**Industrial Area and Buffer Zone  
Sampling and Analysis Plan  
Modification 1**

**May 2004**

Approval received from  
the Colorado Department of Public Health and Environment and  
the U S Environmental Protection Agency  
( )  
Approval letter contained in the Administrative Record

Figure 23  
Confirmation Sampling Data Quality Assessment Logic Flow Diagram

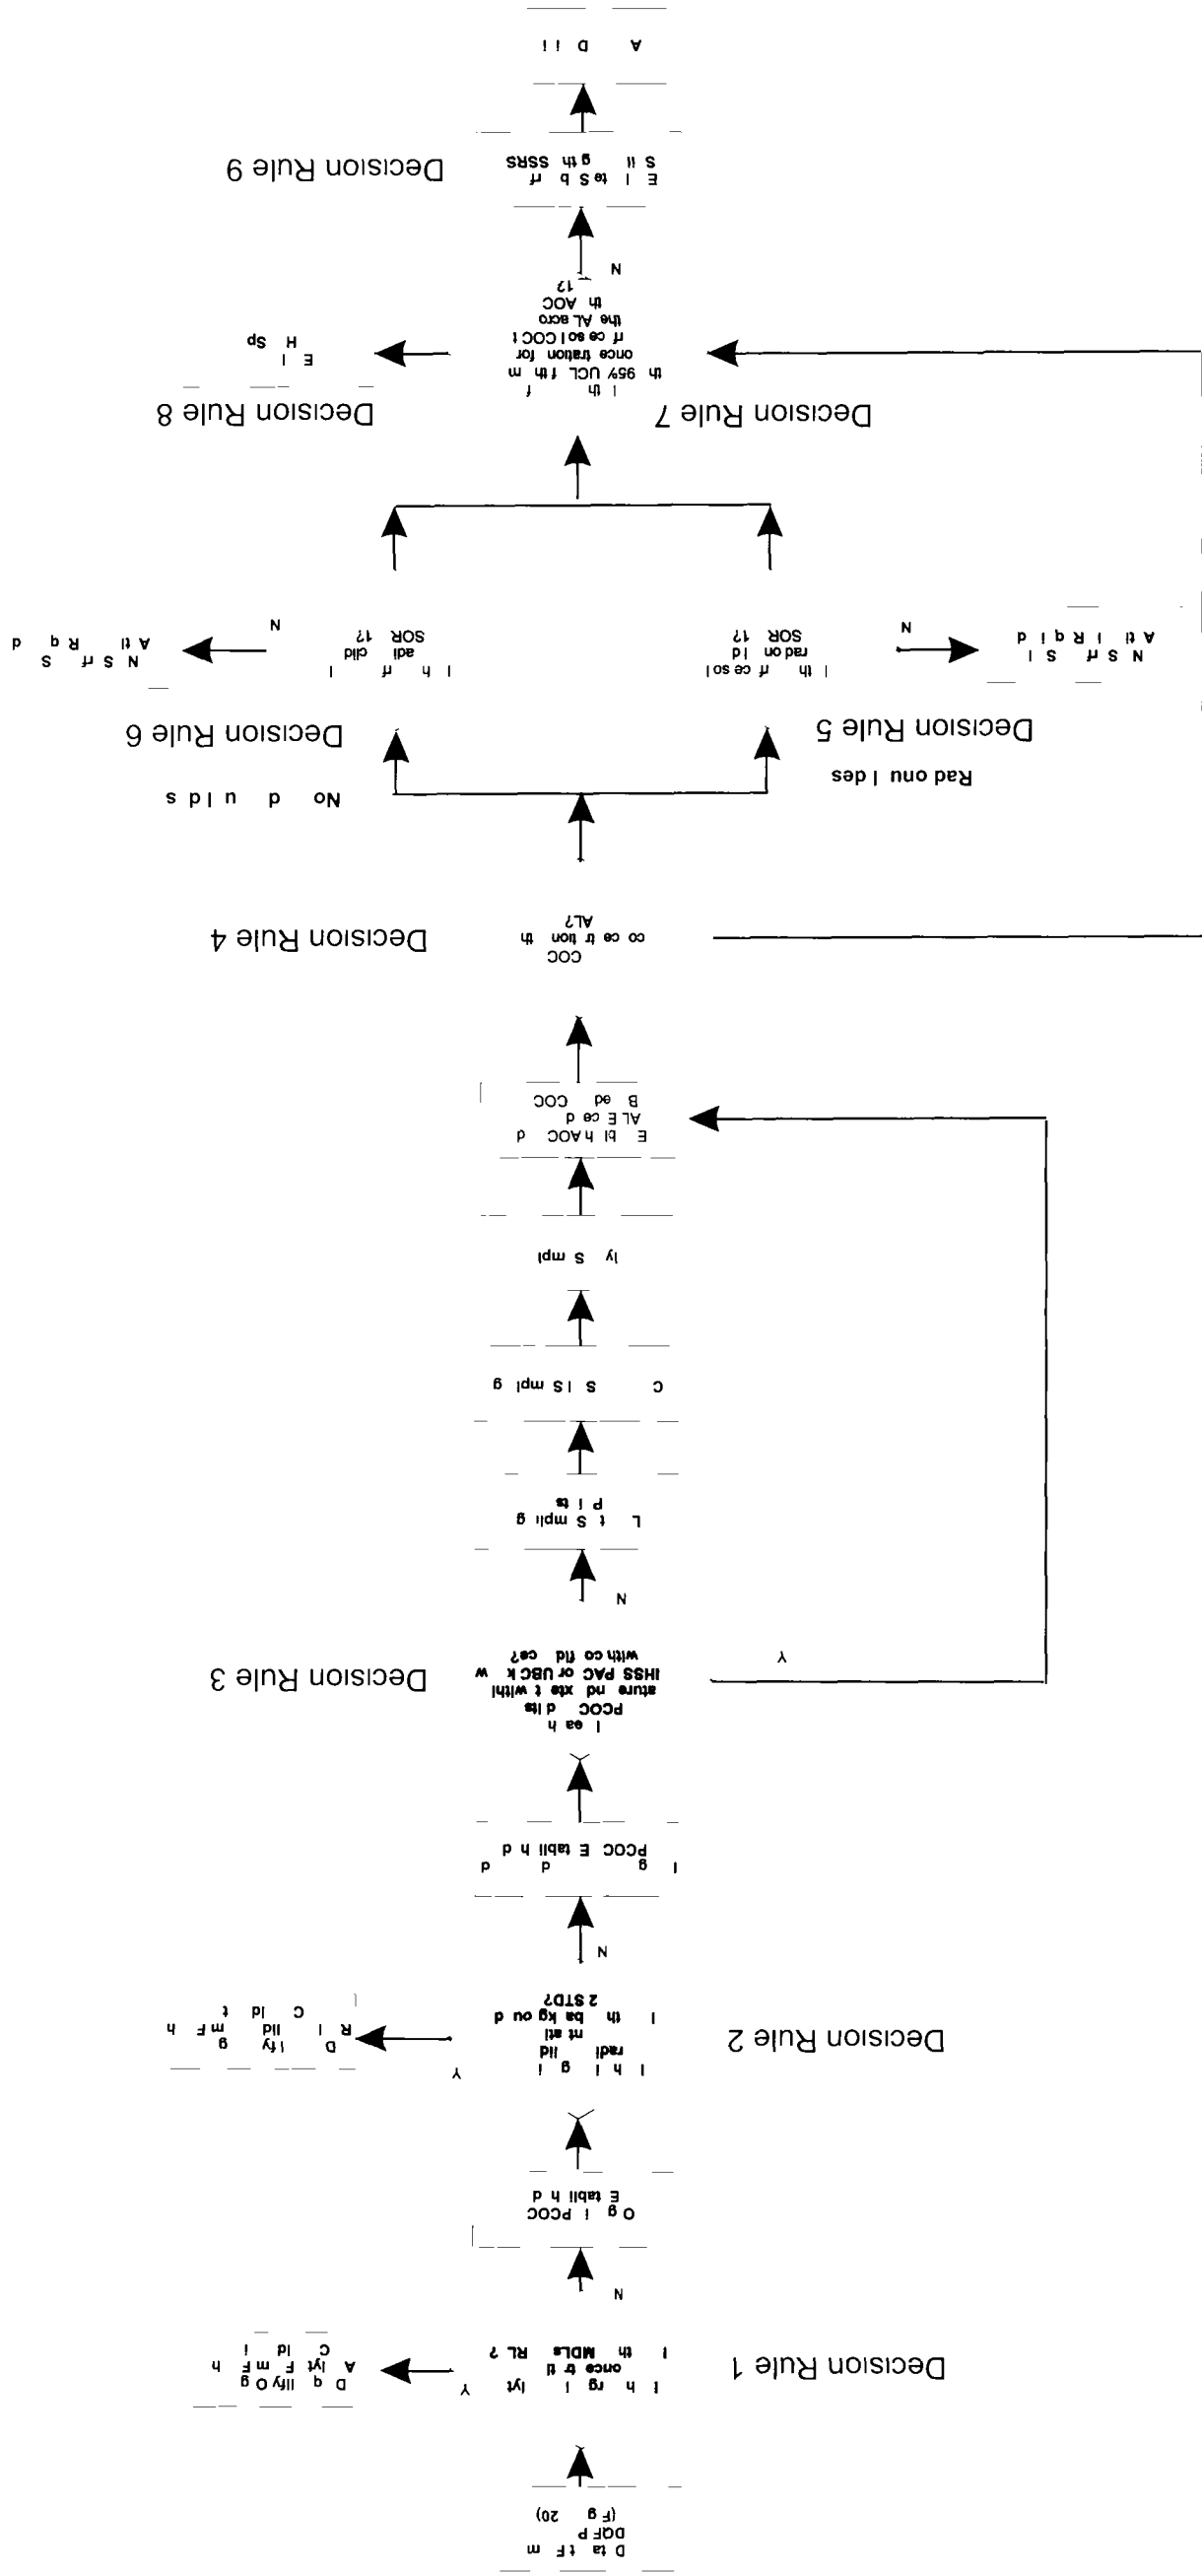
14	<p><u>Figure 23</u> The box at the top of the diagram should read, "Usable Data (see Figure 21)" The words, "for radionuclides", should be deleted from the second decision diamond</p>	<p>The first box at the top of Figure 23 (now Figure 22, page 49) was changed to "Dataset from DQF Process (Figure 20)" A new decision diamond was added for non-radionuclides</p>
15	<p><u>Section 3 1 1 – Decision Rules (page 51)</u> The phrase, "metal and radionuclide PCOCs", should be changed to "inorganic and radionuclide PCOCs" twice in Decision Rule #2</p> <p>A hot spot evaluation step should be included in the decision rules as it is in Figure 24 Section 5 2 should be referenced</p> <p>Decision rules 4, 5, 6, and 7 must be revised to comply with RFCA Attachment 5 and the IGD The following revisions are suggested</p> <p>If a single maximum PCOC concentration in surface soil is equal to or greater than its RFCA AL, aggregation and evaluation as described in decision rule 6 are necessary in accordance with RFCA requirements</p> <p>If surface soil concentrations at a given location for 2 or more PCOCs exceeds 10% of their respective WRW ALs</p>	<p>The phrase "metal and radionuclide PCOCs" in Section 3 1 1, Decision Rules, Decision Rule 2, was changed to "inorganic and radionuclide PCOCs" (page 46)</p> <p>The following decision rule was added to Section 3 1 1 <i>Decision Rules</i>, Decision Rule 9 (page 50) and to Section 3 2 1 <i>Decision Rules</i>, Decision Rule 8 (page 56) "If a single maximum surface soil COC concentration is equal to or greater than the RFCA AL and the ratio of the 95% UCL of the mean concentration to its respective RFCA AL is greater or equal to 1, additional evaluation as a potential hot spot will be necessary "</p> <p>The text is correct as stands Decision Rule 5 (now 6) must be included because it is the radionuclide SOR</p> <p>The following Decision Rule was added to Section 3 1 1, <i>Decision Rules</i>, Decision Rule 7 "If more than one non-radiological contaminant concentration is detected above RLs for organics or background mean plus two standard deviations for inorganics and exceeds 10 percent of the respective WRW AL, then an SOR at a given location will be calculated for those contaminants that exceed 10 percent of their WRW AL If a SOR exceeds 1, the nonradiological carcinogenic contaminants and non-radiological noncarcinogenic contaminants may each be</p>
